Access Compliance Report Public Rights-of-Way (Curb Ramps)

Main Street: CHAPLET_PL Cross Street: CAMEO_DR Location: W

ADA ID: RPRK220103154606 Ramp Type: Type 4 - Parallel Initial Pass/Fail: Fail Overall Compliance: No Severity Score: 16

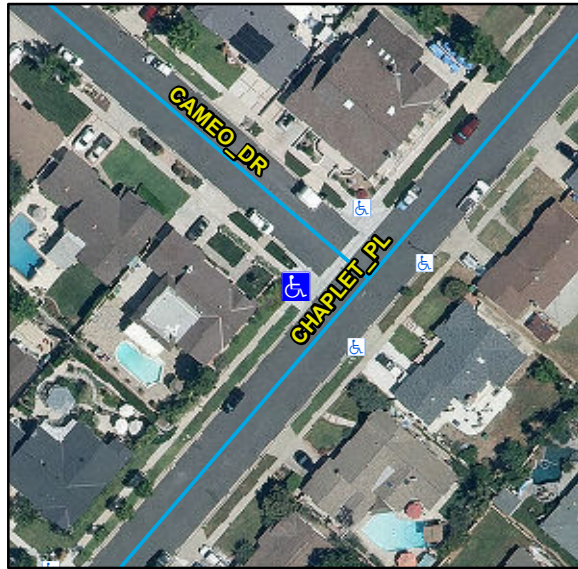
Compliance	Description	Data	Compliance	Description	Data
N/A	Ramp Length LT (in)	101	N/A	Ramp Length RT (in)	101
Yes	Ramp Width LT (in)	99	Yes	Ramp Width RT (in)	94
Yes	Ramp Run Slope LT (%)	2.5	No	Ramp Run Slope RT (%)	11
No	Ramp Cross Slope LT (%)	2.8	Yes	Ramp Cross Slope RT (%)	2
N/A	Landing Present	N/A	N/A	DWS Provided	N/A
N/A	Landing Length (in)	N/A	N/A	DWS Contrast	N/A
N/A	Landing Width (in)	N/A	N/A	DWS Length (in)	N/A
N/A	Landing Run Slope (%)	N/A	N/A	DWS Full Width	N/A
N/A	Landing Cross Slope (%)	N/A		DWS Offset Type	N/A
N/A	Landing Movement Obstructed?	N/A	N/A	DWS Offset Left (in)	N/A
	Landing Movement Type	N/A	N/A	DWS Offset Right (in)	N/A
N/A	Landing Shared	N/A			
N/A	Clear Space	Yes			
N/A	Clear Space To Crosswalk (in)	N/A			
N/A	Marked Crosswalk 1	No	N/A	Marked Crosswalk 2	No
	Crossing 1 Direction	SE		Crossing 2 Direction	NE
	Marked Crosswalk 1 Width (in)	N/A		Marked Crosswalk 2 Width (in)	N/A

Remove & Replace Curb Ramp With Two New Directional Ramps or Equivalent.
